LEGACY CROSSING
PLANNED UNIT DEVELOPMENT ZONING DOCUMENT

Project:
LEGACY CROSSING

LEGACY CROSSING
BUILDING BULK STANDARDS / LAND USE
PLANNED UNIT DEVELOPMENT

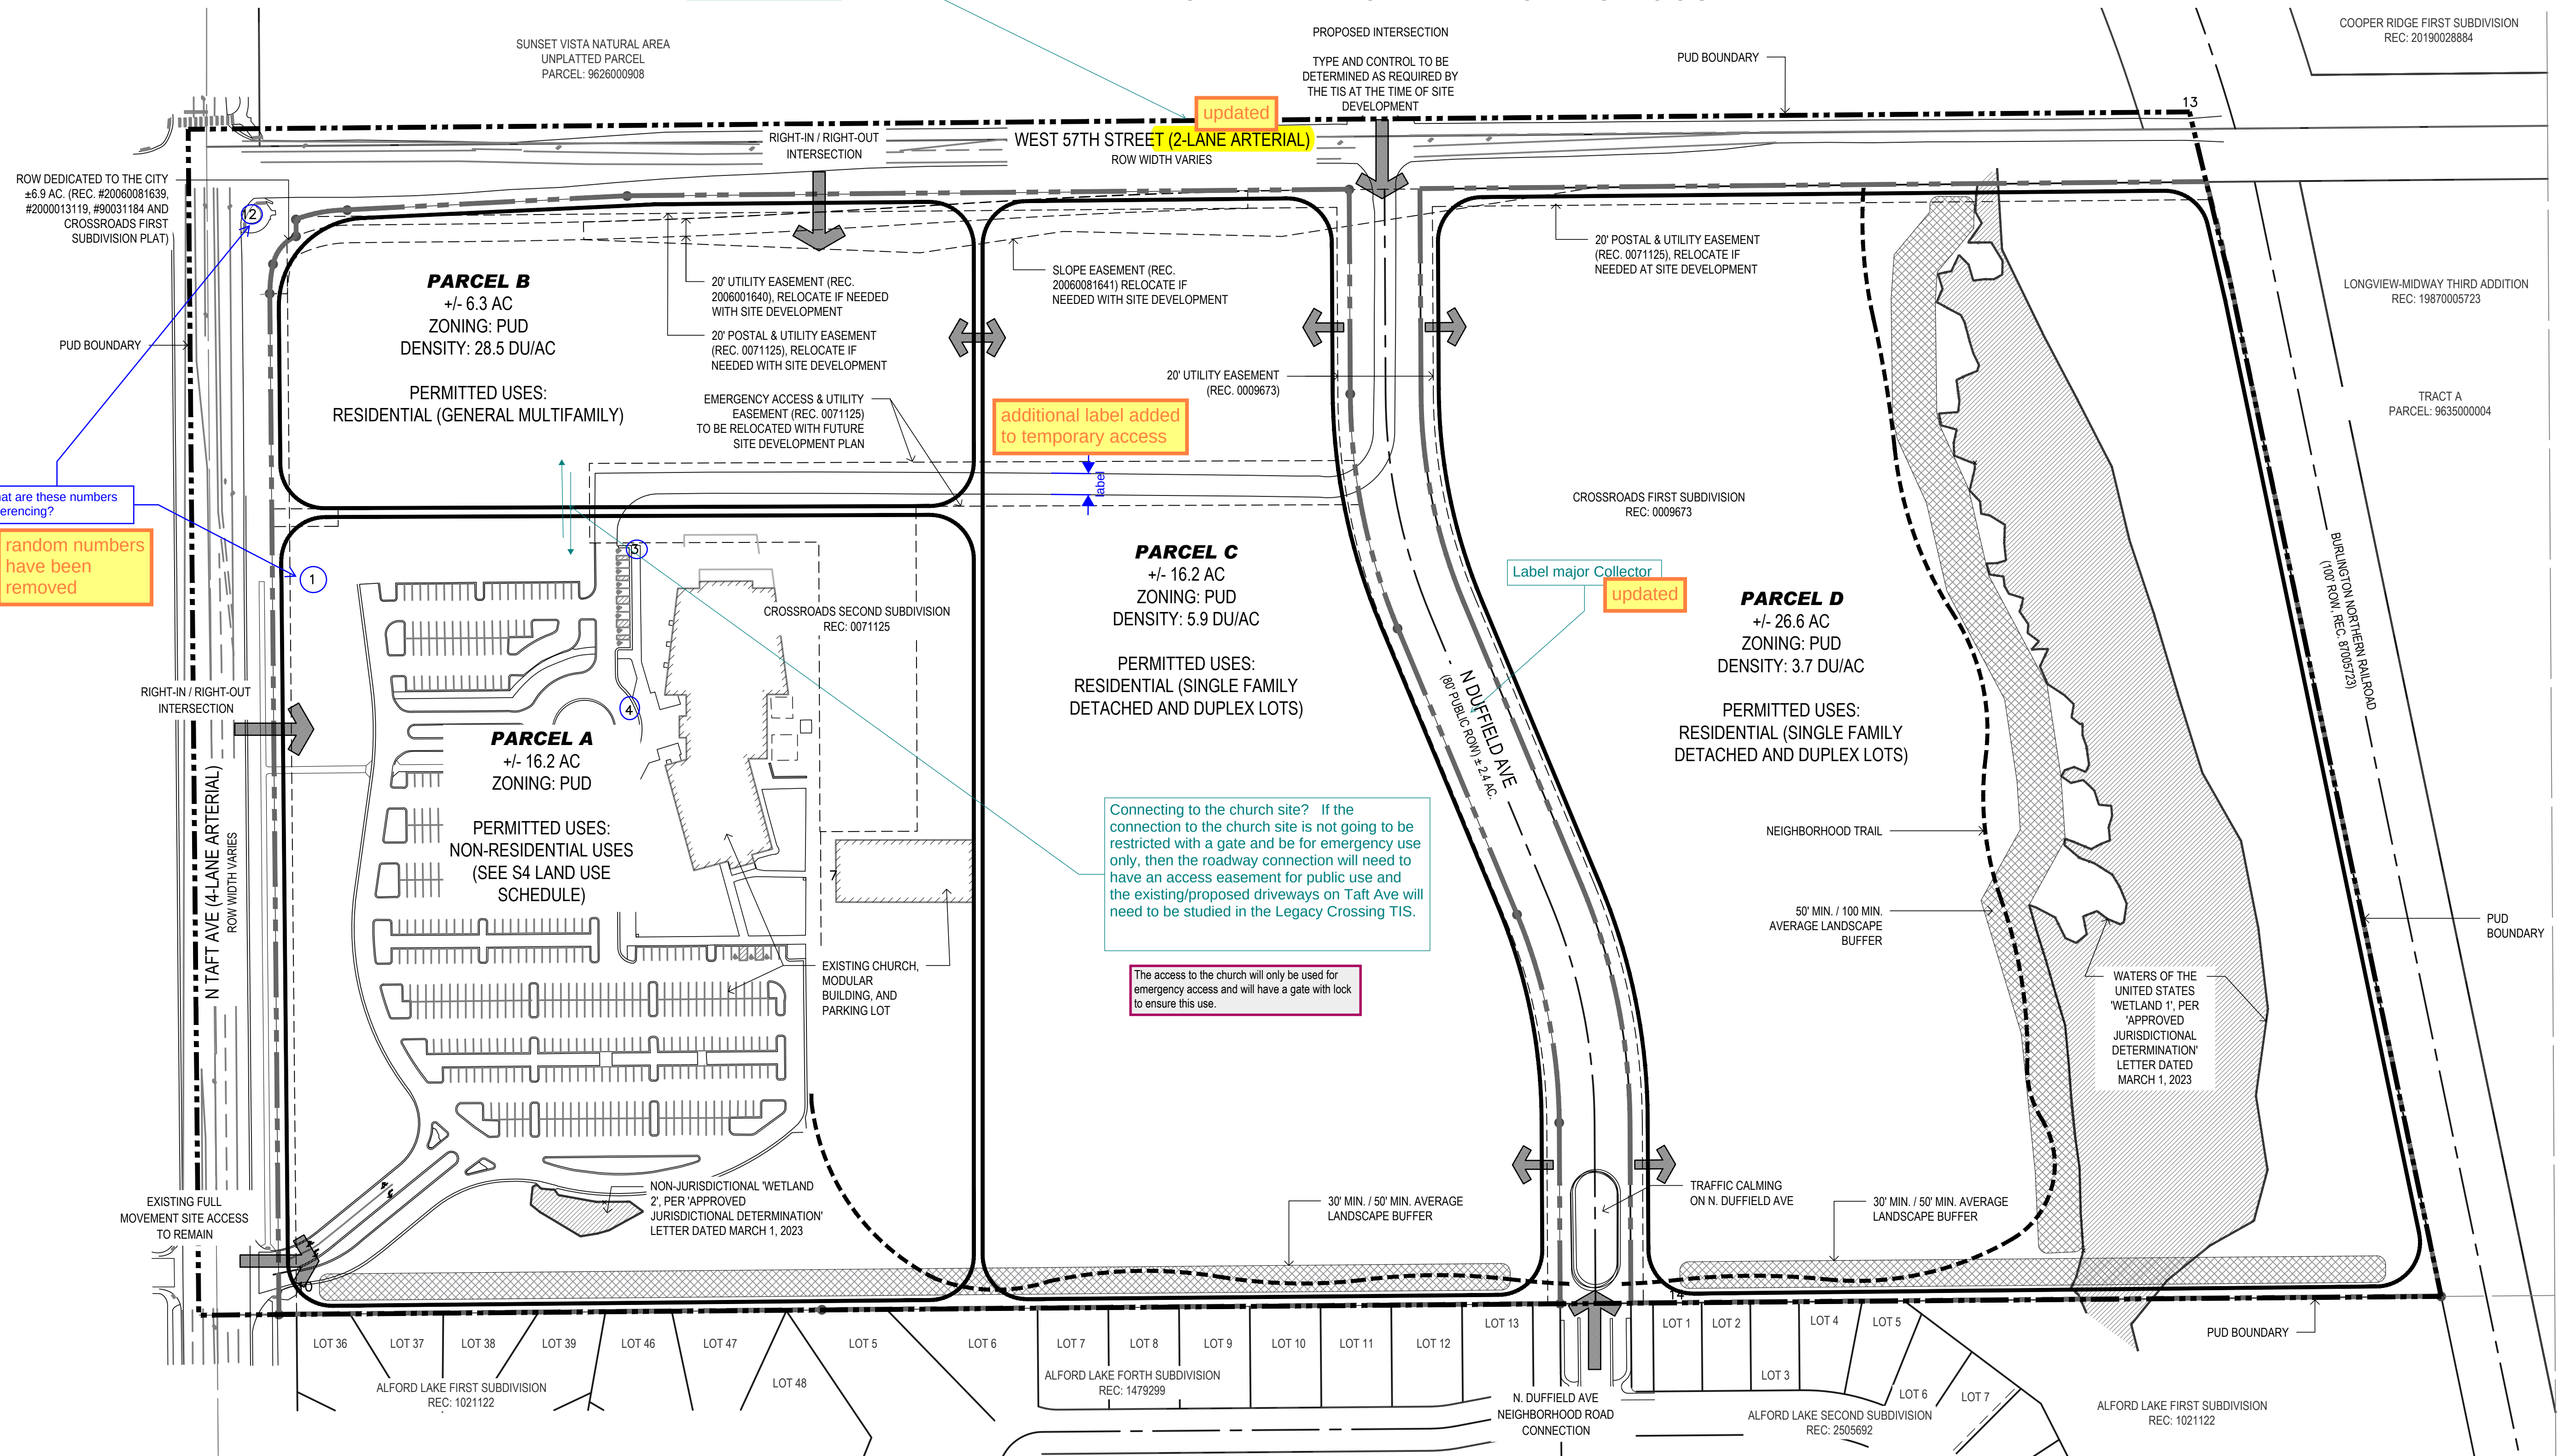
Round up the densities shown in each parcel to match the parcel table.

57th is a 4-lane arterial on the City's Master Plan - Connect Loveland

Add the note regarding SF detached homes required along the southern border of Parcel C and D (from page 4) to this sheet.

updated

note added
to sheet.
